## CERTAIN 2004 THROUGH 2006 MODEL YEAR F-150 AND 2006 MODEL YEAR MARK LT VEHICLES — CLOCKSPrING TO DRIVER SIDE FRONTAL AIR BAG WIRE HARNESS REPLACEMENT

### OVERVIEW

FIGURE 1

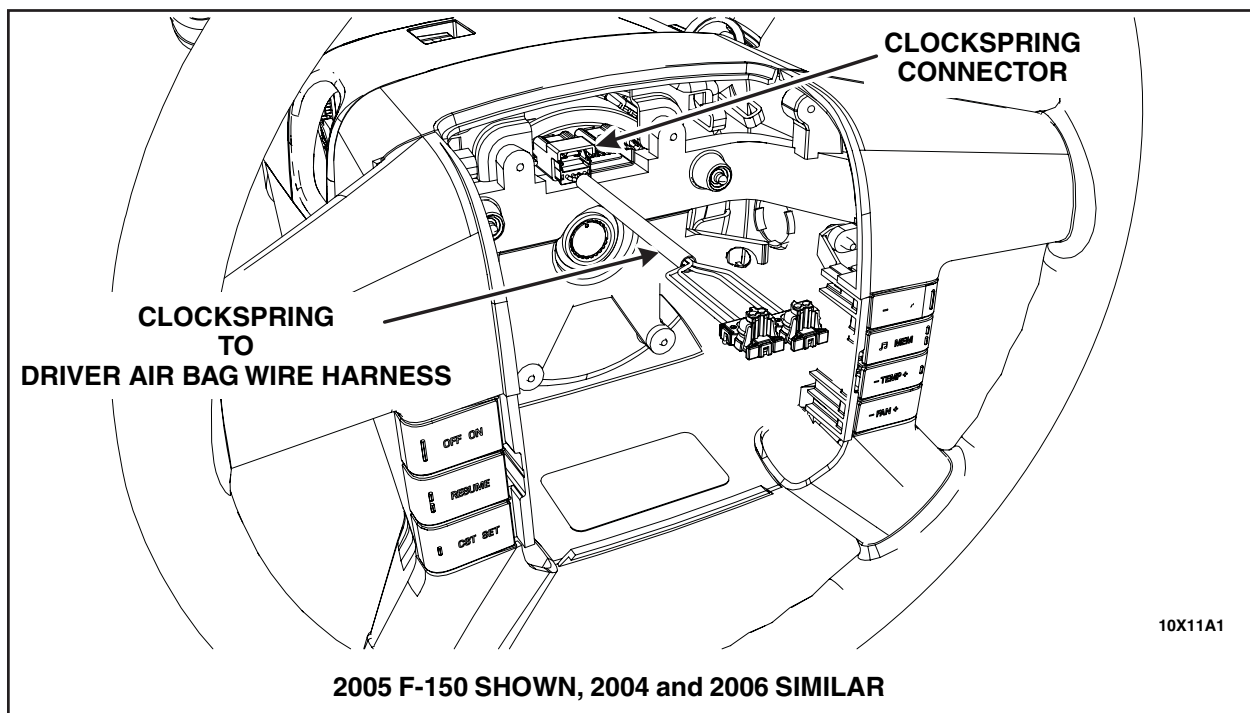
1. Remove the driver air bag. For additional information, refer to the appropriate WSM, Section 501-20B.
2. Release the clockspring connector lock and disconnect the harness from the clockspring. See Figure 1.

3. Install the **new** clockspring to driver air bag wire harness using the following sequence:
  1. Connect the harness to the clockspring.
  2. Make sure the harness lock at the clockspring is seated.
  3. Connect the harness to the air bag.
4. Install the driver air bag. For additional information, refer to the appropriate WSM, Section 501-20B.
